April 18, 2024 2023-MDT-6301

Re: Addendum No. One (1)

Replacement of Existing Passenger Boarding Bridges, Phase II Harrisburg International Airport (MDT) SARAA Project No. 2023-006

2023-006 PBB FOUNDATION DETAILS 22 of 23 **IDENTIFIER:** S501 **AS SHOWN** MARCH 20, 2024

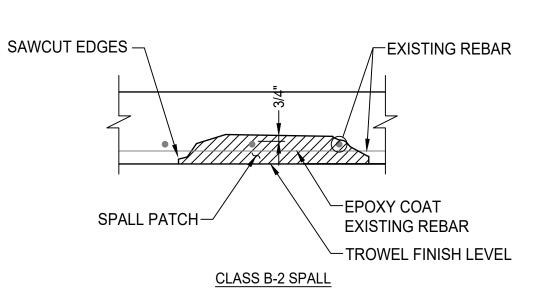
- **1.03 INSERT** Sheet S501, PBB FOUNDATION DETAILS, attached to this Addendum No. One (1), after Sheet 21 of 23.
- **1.04 INSERT** Sheet S502, EXISTING PBB FOUNDATION REPAIR DETAILS, attached to this Addendum No. One (1), after Sheet 22 of 23.

- A11. Sheet S501, PBB FOUNDATION DETAILS, and Sheet S502, EXISTING PBB FOUNDATION REPAIR DETAILS, are being issued and are attached as part of this Addendum No. One (1).
